PLANNING & ZONING AGENDA ITEM #5

SUBJECT: Approval of a Final Plat for Parkview Crossing Plat 10

RE: Parkview Crossing Plat 10 – Final Plat

FINAL PLAT PARKVIEW CROSSING PLAT 10 WAUKEE, IOWA

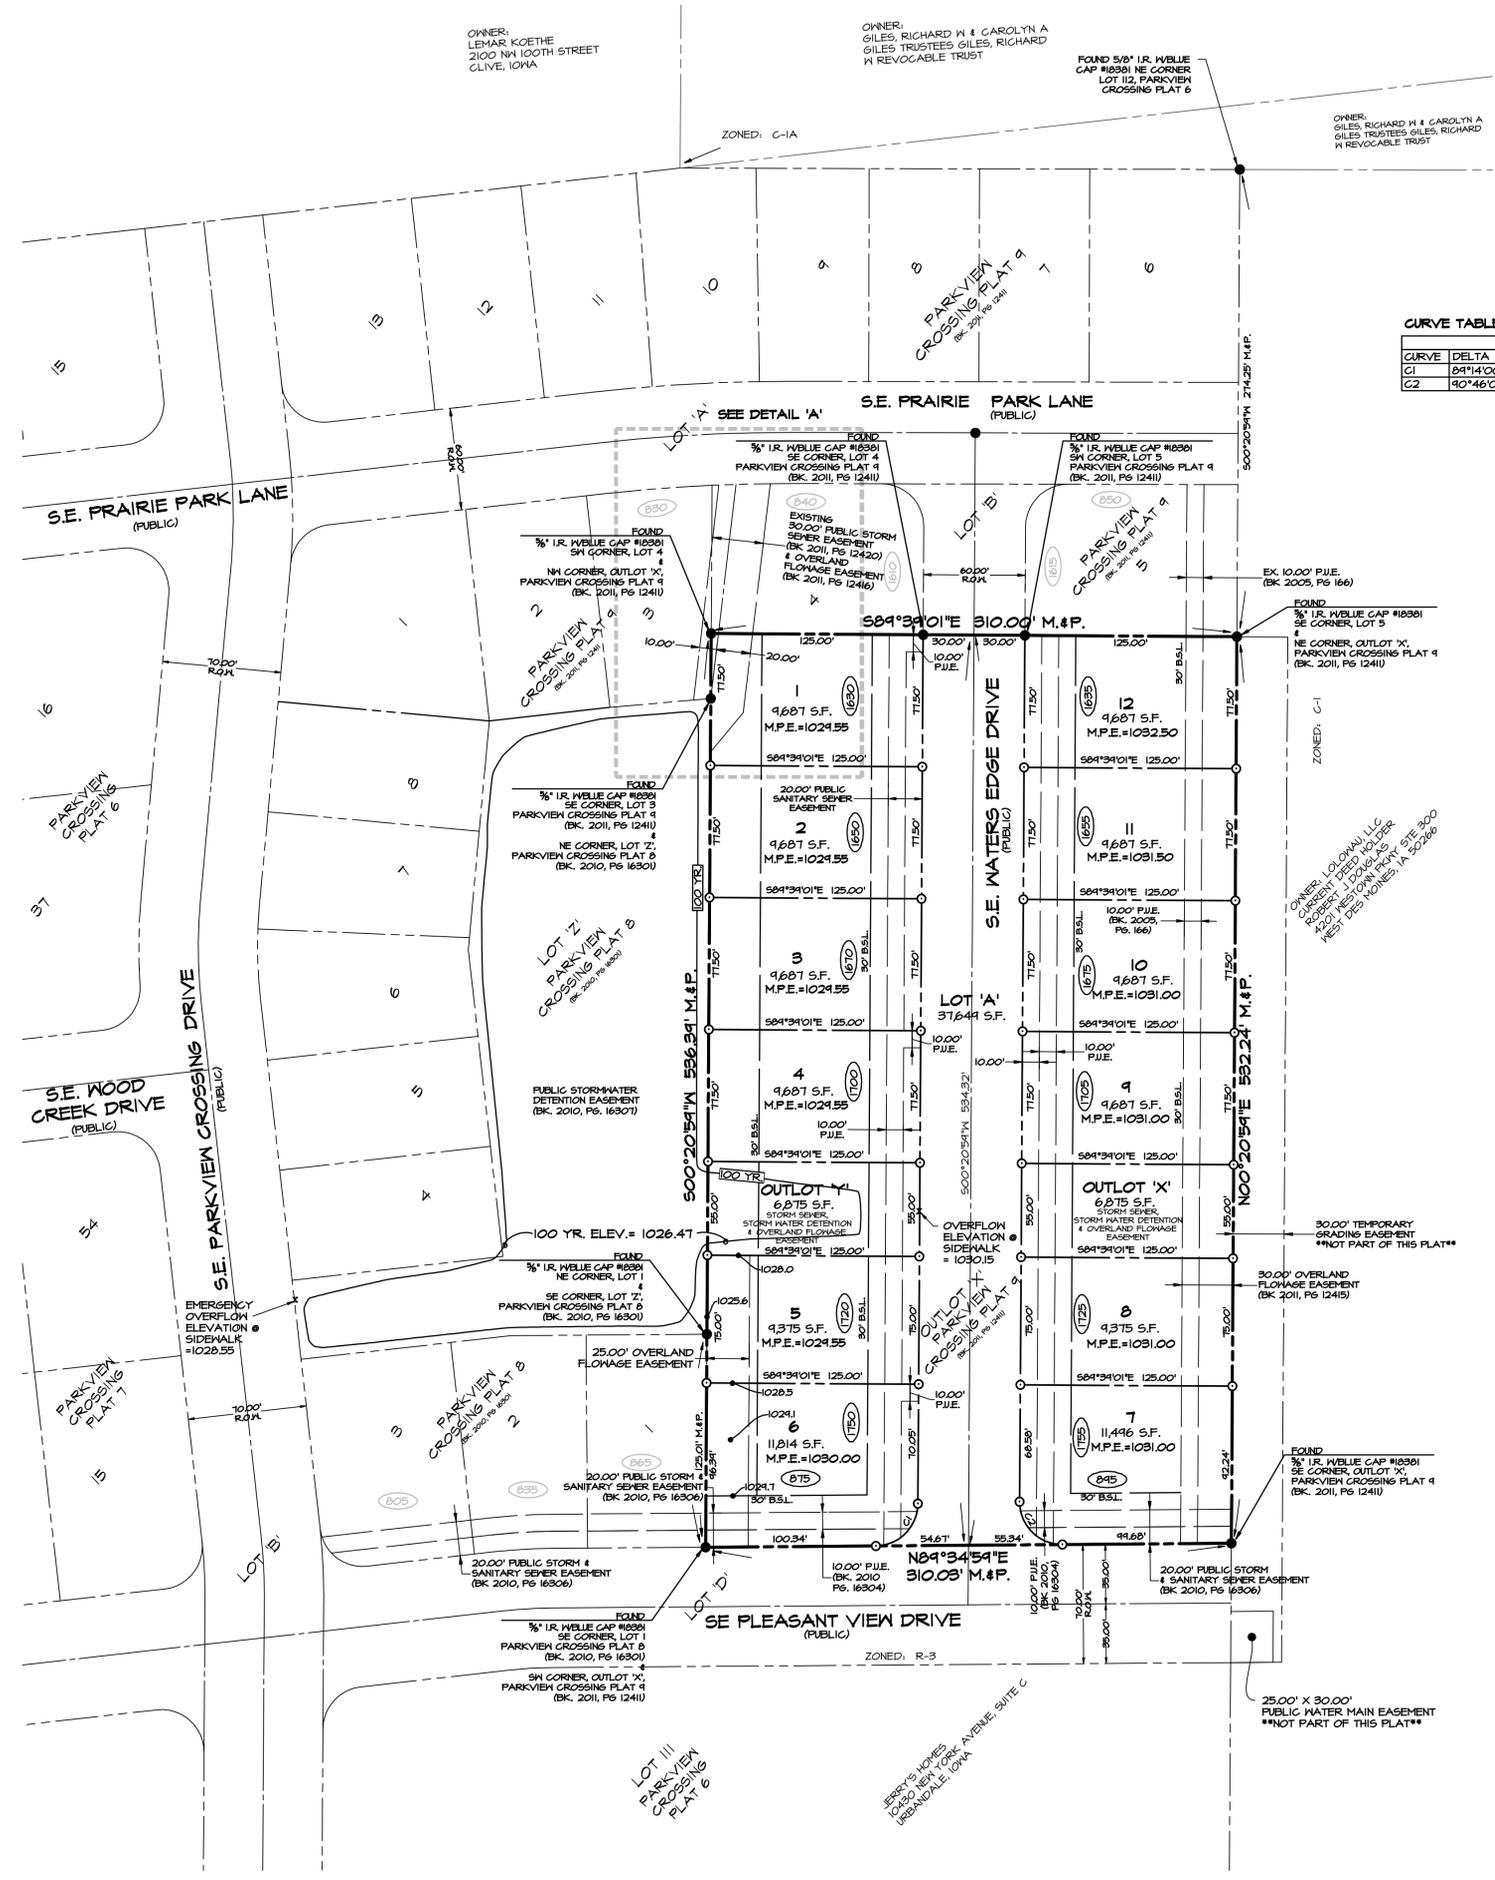
1. All existing easements indicated through lots within Parkview Crossing Plat 8 should be called out for clarity and referenced with the applicable Book and Page for clarity. **The easements not related to this plat have been removed from the drawing.** *It is not standard practice to show offsite easements on a final plat. Only recorded final plats and easements documents should be used when inquiring about an offsite easement. Attached to this response letter are several examples of Final Plat indicating easements adjacent to the recorded plat. Staff still maintains the request to show all adjacent easements on the final plat with the recorded Book and Page in half tone.*

2. The existing trail easement running through the rear yards of Lots 7 – 12 should be indicated on the final plat for abandonment as done for Lots 6 – 13 of Plat 9. **The trail easement was vacated on the Final Plat of Parkview Crossing Plat 8.** *Any reference to the vacated easement has been removed from the drawing. Noted. Staff will verify that the easement was officially vacated by the City with the recording of Plat 8 and/or 9.*

3. Staff would request that the existing addresses for the lots adjacent to the plat be indicated in half tone for clarity. Please address. **(Shown on Survey)**

4. Outlots X and Y should be indicated with the storm sewer, storm water detention, and overland flowage easement designation as described in Note #3 on the final plat for clarity. **(Shown on Survey)**

5. A storm water detention easement should be provided for the area in the rear of Lot I where the 100 year flood limit extends into the property. **The grading in this area will be updated to remove the 100 year flood limit from Lot I and will be contained within Lot 'Z' of Plat 8.** *The final grading has not been completed and can be adjusted without affecting the volumes of the pond. Noted.*

6. Temporary siltation basin easements should be provided for the basins adjacent to Lot Z, and Outlot Y in Lots 5, 8, and 9 as proposed in the construction drawings and SWPPP. **The siltation basins will not exist at the time of platting. The flume construction will remove the temporary silt basins on the east side of the plat prior to filing of the final plat. The remainder of the site should be stabilized and not require the west temporary silt basin. It is not our intent to file the final plat prior to site construction and stabilization being complete. Noted.**

7. The street lighting symbols along SE Waters Edge Drive should be eliminated from the final plat. **(Deleted signs & light poles from plat)** *This was included on the first submittal because it was on the city checklist. Noted.*

8. As-built spot elevations should be provided through the rear yards of Lots 7 – 12 where the flume exists identifying the low point where the flume crosses each property line. Spot elevations should also be provided for Detail A identifying the low point of the overland flowage easement, where the

9. The 25 foot overland flowage easement in the rear yard of Lots 5 and 6 should be indicated on the final plat consistent with the construction drawings. Additionally, spot elevations should be provided through the overland flowage easement indicating the low point of the easement at the property lines and mid point of the easement. (Shown on Survey) **This will also need to be included once construction has been completed to verify grades are as proposed by the construction drawings.**

10. The 30 foot temporary grading easement adjacent to lots 7 – 12 should be indicated on the final plat. (Shown on Survey – This cannot be part of this plat since it is not owned by Jerry's Homes, Inc. This should be defined by a separate document and/or Easement Exhibit) See my response to comment #1. **SEE RESPONSE TO COMMENT #1 AND ATTACHMENTS**

11. The 25 foot by 30 foot water main easement at the east end of SE Pleasant View Drive should be indicated on the final plat. (Shown on Survey – This cannot be part of this plat since it is not owned by Jerry's Homes, Inc. This should be defined by a separate document and/or Easement Exhibit) See my response to comment #1. **SEE RESPONSE TO COMMENT #1 AND ATTACHMENTS**

12. Note #5 should be revised to clarify the installation of sidewalk and corresponding truncated domes at the time of individual lot build-out, citing the installation of sidewalk through Outlots X and Y completed as a part of the public improvements to the plat. (Updated note #5) **Noted.**

13. Note #6 can be **eliminated** from the plat. (Added as per the preliminary plat comments. This note was required on previous plats.) **Please eliminate from this final plat.**

14. A note should be added to the plat identifying the intended ownership and maintenance responsibilities related to Outlots X and Y. (To be decided) *Please refer to the attached documents that were recorded with plat 8. I think we need to amend the maintenance agreement so costs are divyed up between 33 lots instead of 35 per the preliminary plat. I am not sure if the homeowner's association and declaration docs need to be undated too? Currently Lot Z is owned by the city but maintained by the association. It is my recollection that outlot 'X' and 'Y' will be owned by the association, but I think the maintenance agreement should clarify who is to maintain the box culvert and overland flowage areas which are outside of the 100 year pond elevation. Please review the currently filed documents and let us know how to proceed. **The detention pond and outlots are to be maintained by the Homeowner's Association. Please see the attached document recorded as a part of Plat 9. It is anticipated that a similar update will be made and recorded with Plat 10 identifying this requirement. Staff still maintains a desire for a note to be added to the final plat identifying the Homeowner's Association's responsibility for maintenance.***
